SUBJECT: FORWARDING MEETING SUMMARY DATED JANUARY 27, 1993

Enclosed is the summary of a meeting held between the staff and GE on January 11 through 21, 1993, to discuss inspections, tests, analyses, and acceptance criteria.

Enclosure:
Meeting Summary
dtd 01/27/93

Figure 2.11.9 Reactor Service Water System

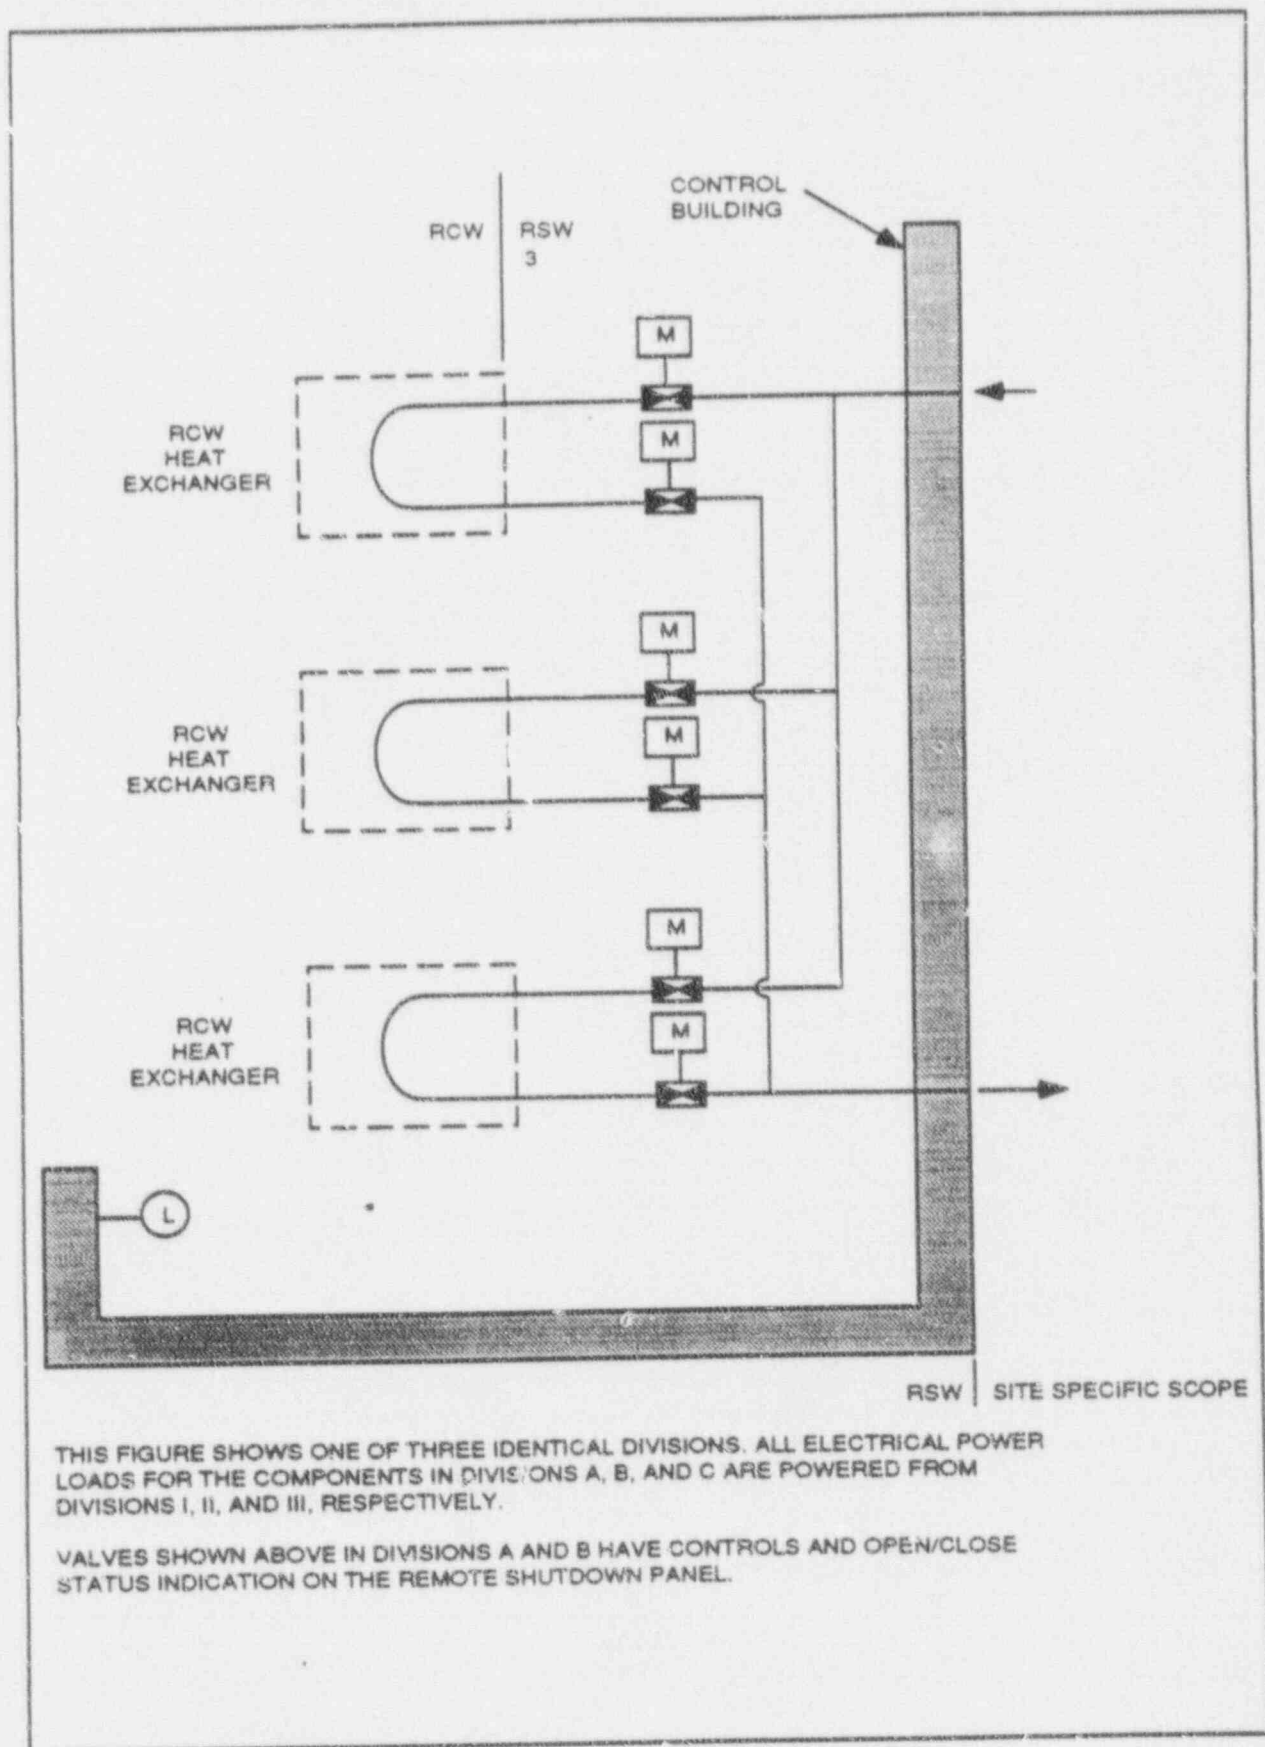
- ① CORRESPONDING SSAR CHANGE NEEDED TO ADDRESS MAXIMUM FLOOD HEIGHT
- ② WATER LEVEL SENSOR MOVED TO CONTROL ~~ROOM~~ BUILDING ITAAC (NEEDS TO BE PICKED-UP). ADD CORRESPONDING CHANGE TO SSAR.

- ③ Water level sensor moved to control building ITAAC. Add corresponding change to SSAR

Figure 2.2.4 Standby Liquid Control System

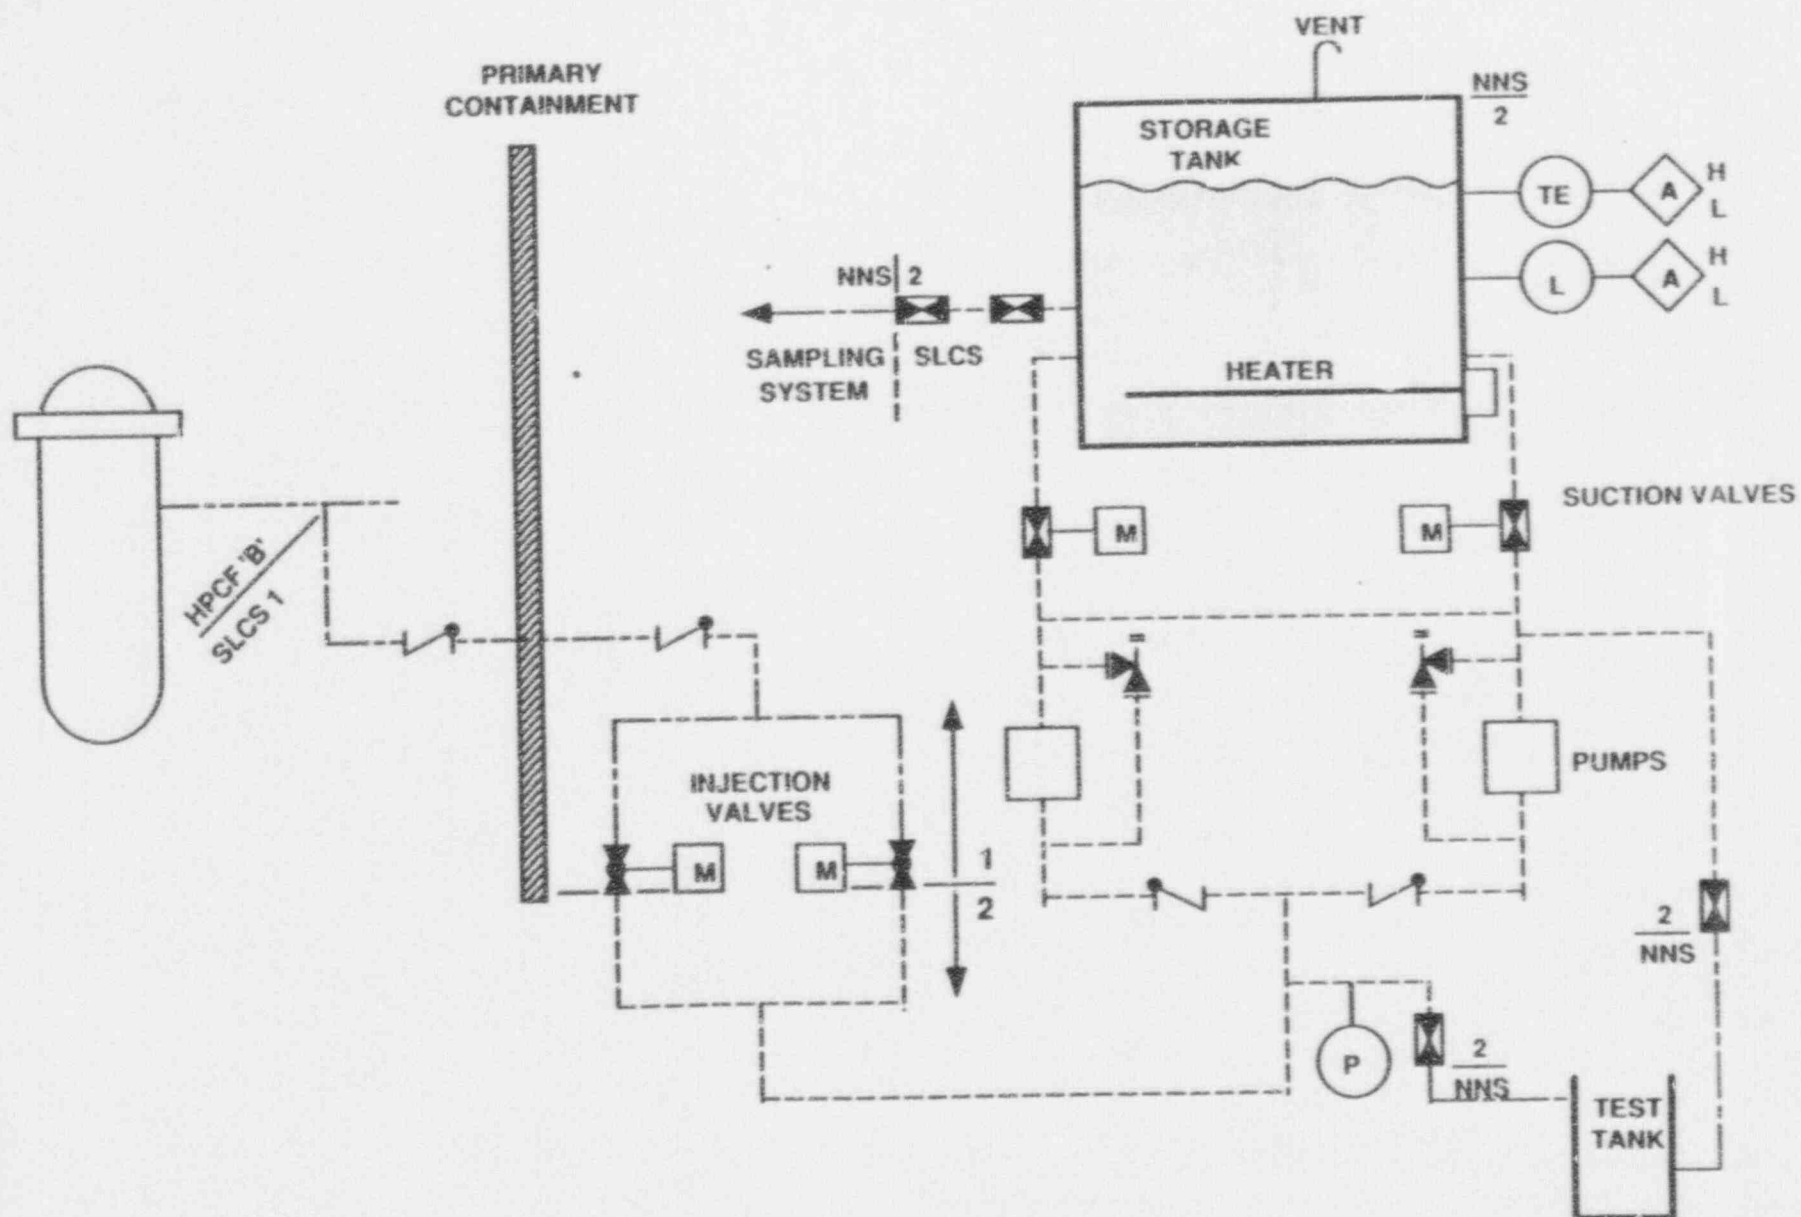
(A) VERIFY PRE-OP TEST PROCEDURE
~~VERIFIES~~ TESTS ABILITY OF
EACH PUMP TO DELIVER CAPACITY
WITH OPPOSITE RELIEF VALVE
OPEN OR REMOVED.

(B) ADD MOV BOILER PLATE

Figure 2.10.1 Turbine Main Steam System

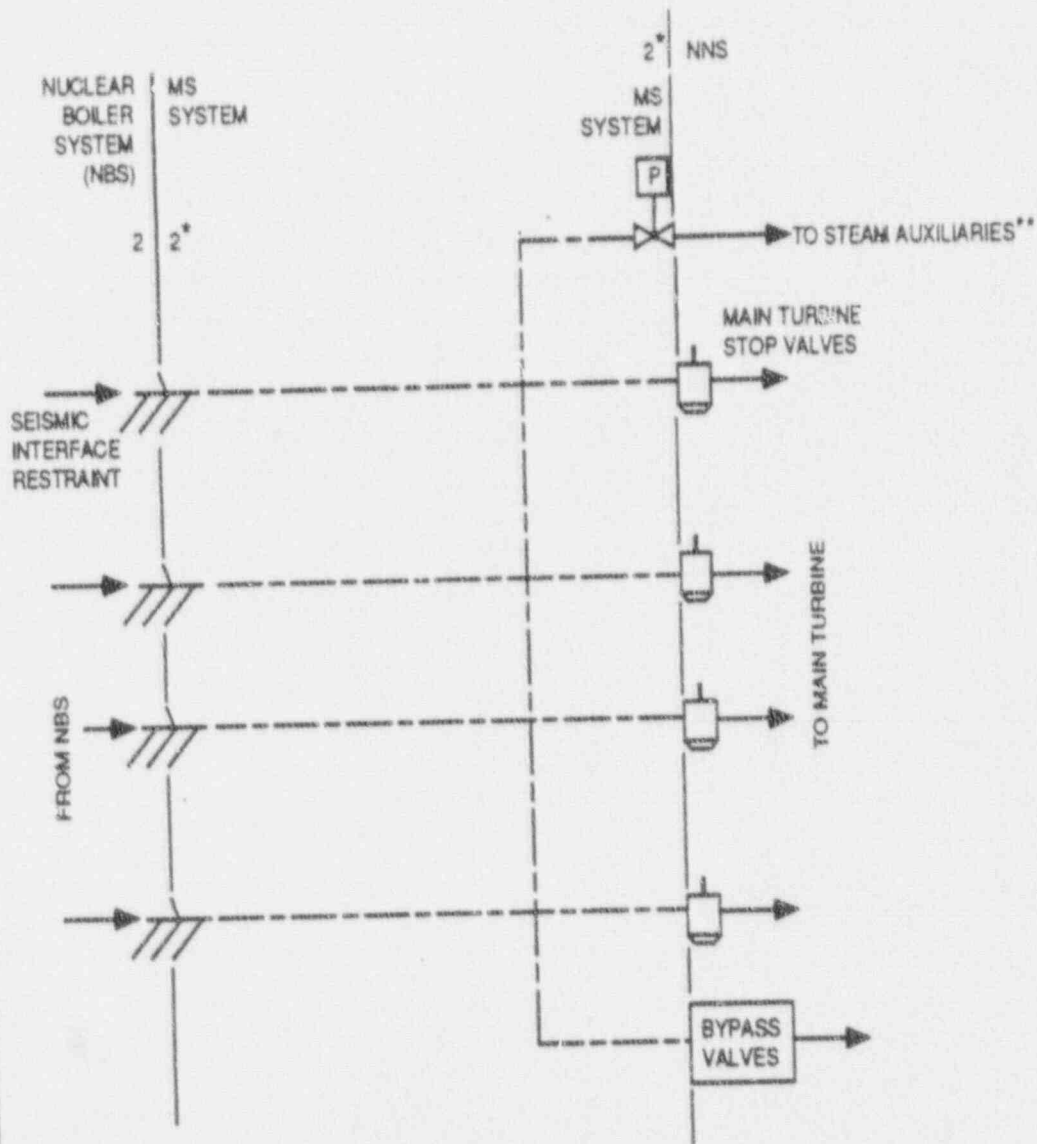
(A) UPDATE SAR TO SHOW
STEAM AUXILIARIES VALVE
NOW IN SYSTEM (2)

~~(B) ADD BOILER PLATE ON
CONFIGURATION~~ ✓

~~(C) ADD TO DESIGN DESCRIPTION~~ ✓

~~(D) ADD HYDRO BOILER PLATE~~ ✓

(F) Revised SSAR - Description of Main
Steam Line
(attached draft) ✓

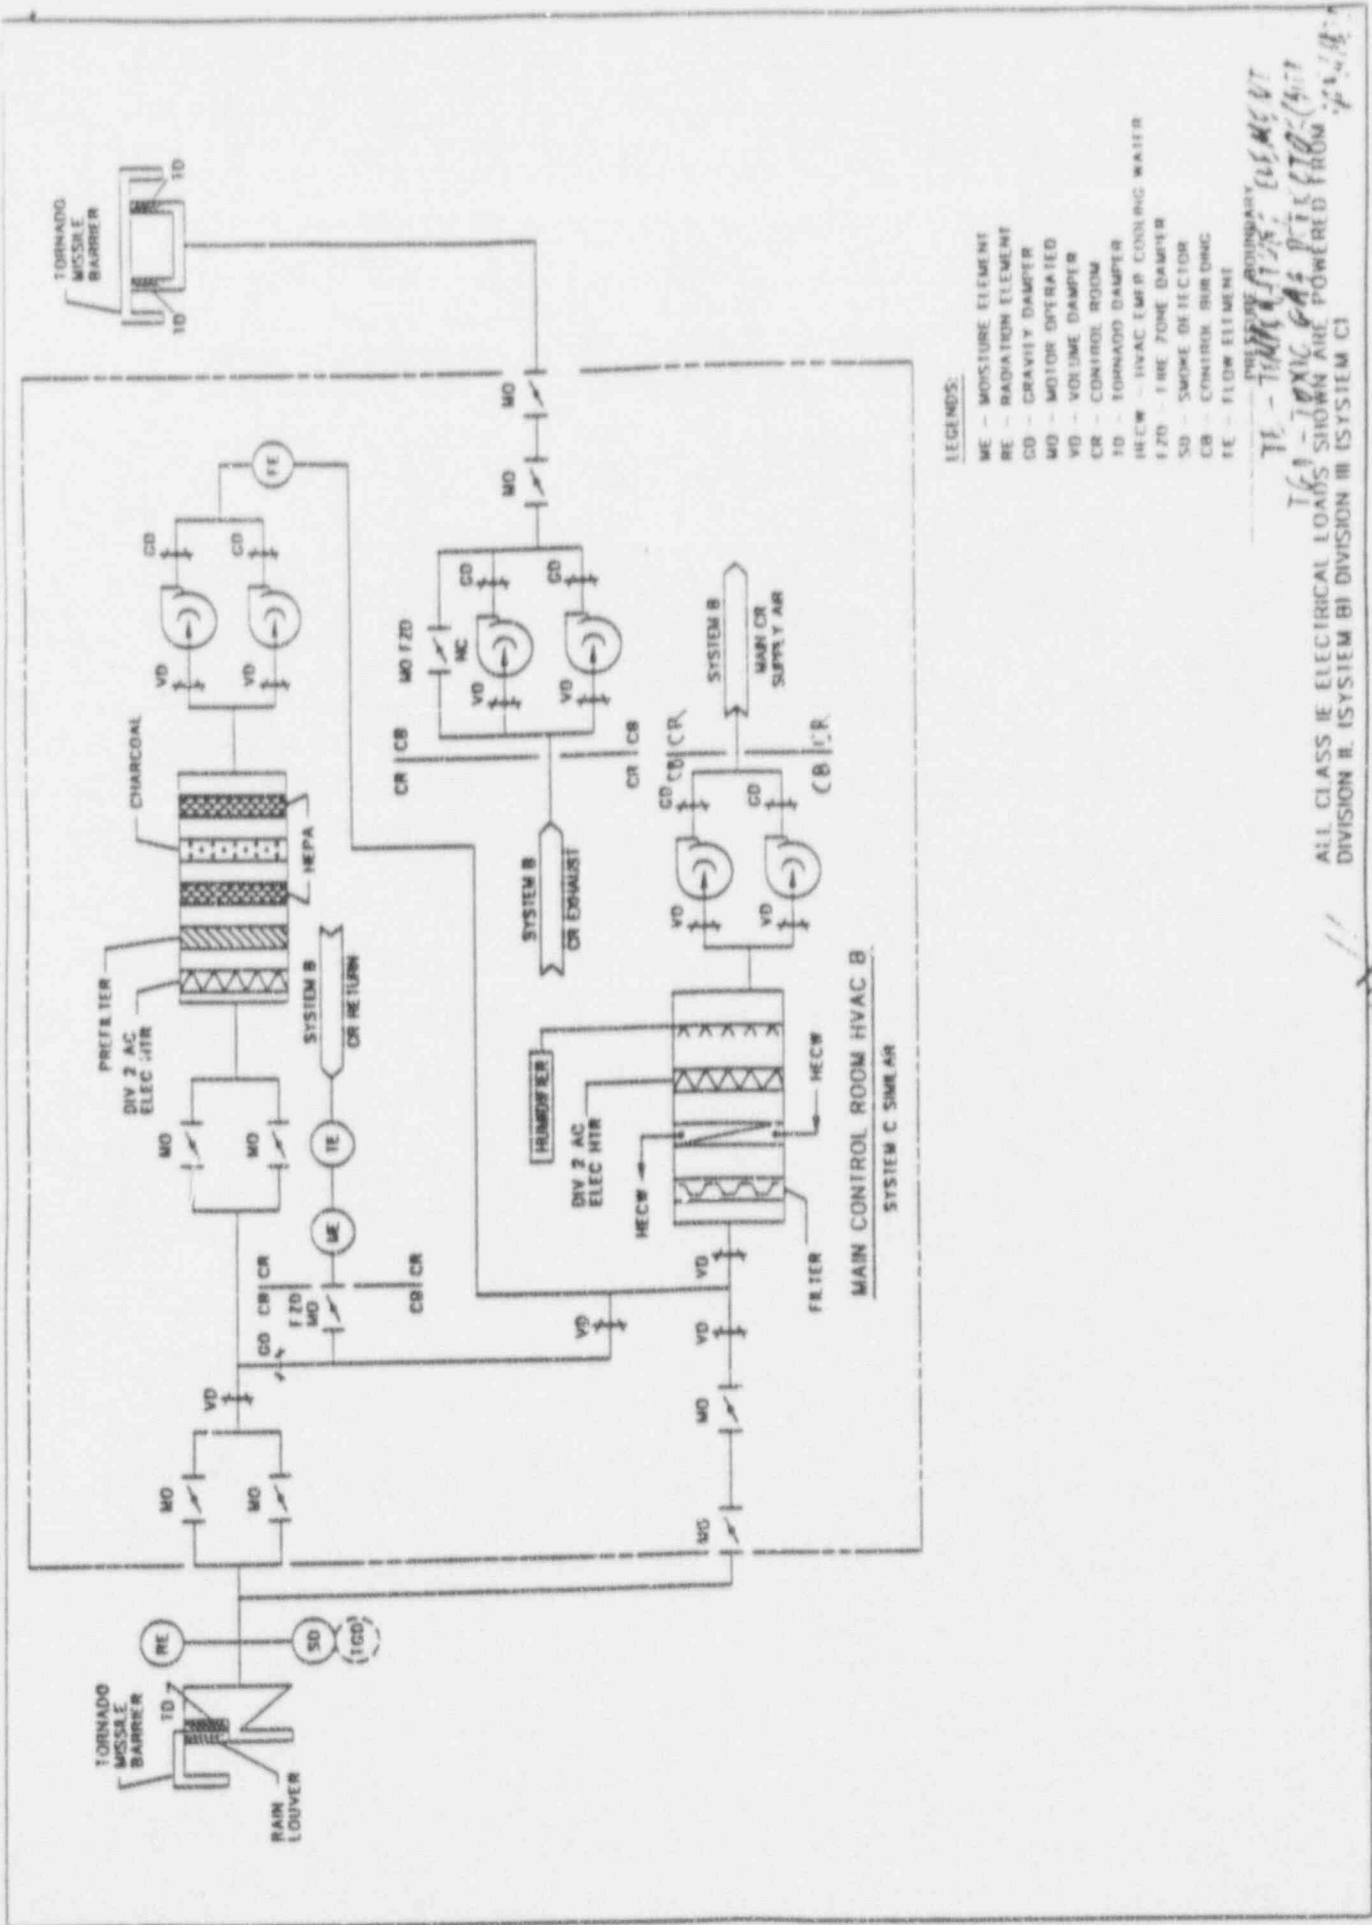
(A) VERIFY $1300^3/\text{HR}$ IS CORRECT ✓
DESIGN BASIS NUMBER. ALSO,
CHECK USE OF SECTION 3.7 RADIATION
PROTECTION

~~(B) INCLUDE BOUNDS OF CONTROL ROOM
PRESSURE BOUNDS
USE STD BOILER PLATE FOR ^{STET}
POWER SUPPLIES~~ ✓
